RESPONSE TO REQUEST FOR ADDITIONAL INFORMATION

US-APWR Design Certification

RAI NO.: NO. 340-2004 REVISION 0
SRP SECTION: 03.08.05 - Foundations
APPLICATION SECTION: 3.8.5
DATE OF RAI ISSUE: 04/21/2009

QUESTION NO. 03.08.05-14:

Figure 1. Timeline of Loading for Settlement Analysis. Notations: D = Dead Loads, L = Live Loads, B = Loads from Backfill.

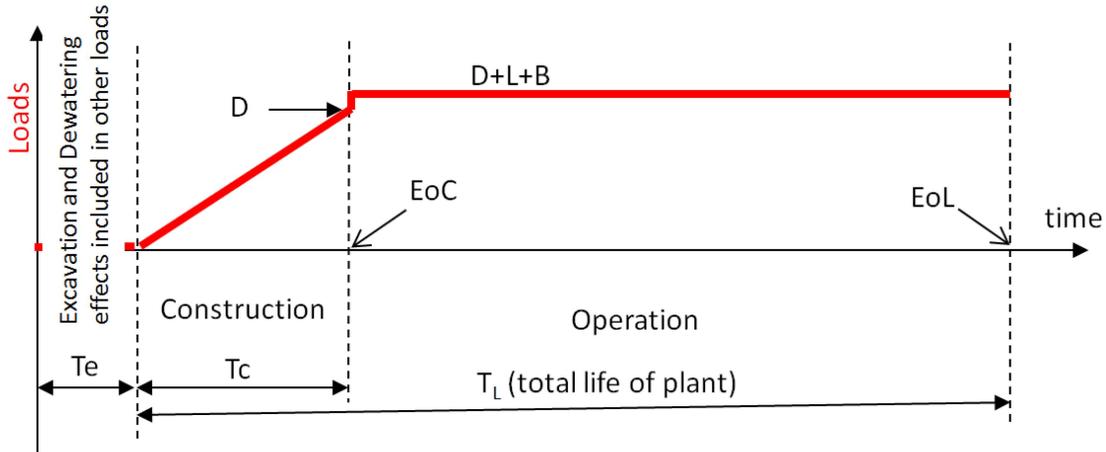
- (1) describe its analytical method used to calculate the settlement and differential settlements of the basemat with respect to the proposed construction sequences, and
- (2) provide the curves of the basemat settlement vs. different stages of construction, and differential settlements of the basemat vs. different stages of construction, for the four types of soil conditions assumed in the DCD.

This phase of the settlement analysis considers a generic construction schedule, as follows (Figure 1):

- a) **Excavation.** This phase is assumed to be completed in $T_e = 6$ months,
- b) **Construction.** The time of construction is taken in the settlement analysis as $T_c = 38$ months. This represents 44 months from first concrete to fuel filling minus four months for testing (hydro-tests, shakedown, etc.) and an additional two months for major pipe

- c) **Operation.** The operation life of the plant is considered $T_L - T_C = 60.5$ years, representing 40 years (standard plant commission period), plus 20 years (possible life extension), plus six months removed/eliminated from the construction time that are conservatively added to the operation time. T_L represents the total life of the plant, including construction and operation - see Figure 1.

The loading scenarios used for each structure along with the corresponding settlements are illustrated in Figure 1. There are different sets of loads acting during the life of the plant that contribute to short term and long term settlements:

Figure 3. Example of Basemat Concrete Placement Zones (Sequences) between Elevations -33'-0" and -26'-4" (Zone Numbering corresponds to Sequentially Outward Construction)

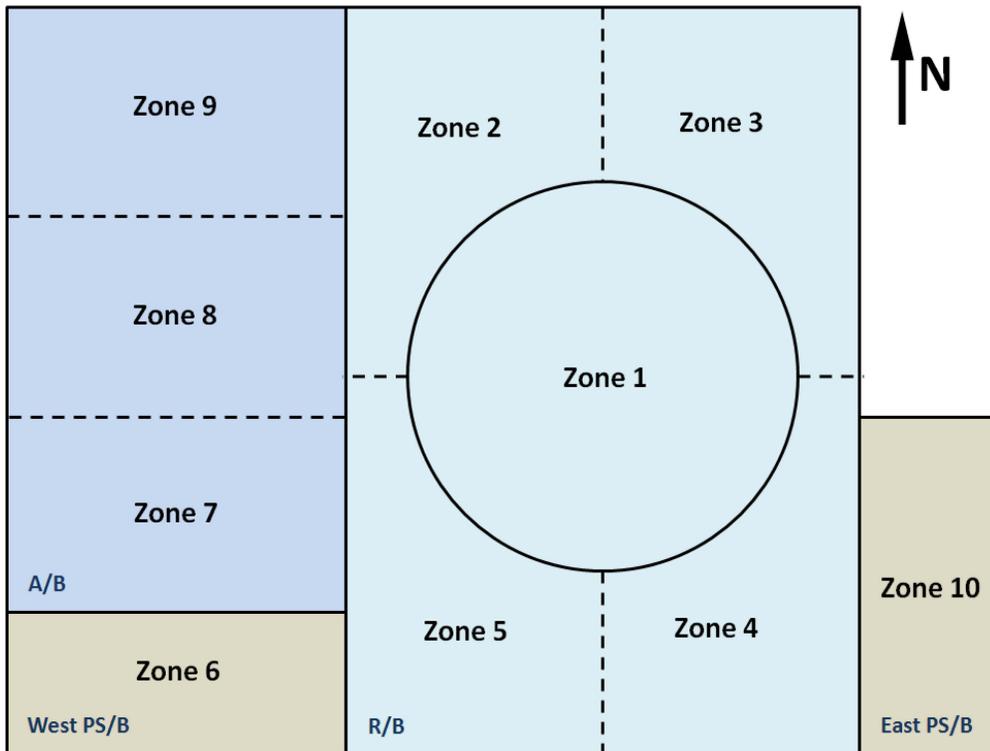
As a result of the Public Meeting of October 31st, 2013, the following additional question was raised: Has MHI performed or will MHI perform “dishing” analysis for the basemat? If not, why not?

- Stage 2: Upper half of basemat (between elevations -33'-0" and -26'-4") - 10 sequences (see Figure 3), 3 scenarios (sequentially inward, sequentially outward, and random construction)

ANSWER: MHI will perform dishing analysis for the basemat. As described before, in Part (B) of the answer, a significant part of the subgrade will be included into the FE analysis domain, with the subgrade represented by continuum finite elements, to ensure capturing dishing effects. The iterative procedure for estimating the secant equivalent elastic moduli mentioned in Part (A) of the answer and presented in detail in the answer to RAI 1045-7141, Question 03.08.05-59, includes the effect of local settlements on the secant modulus values.
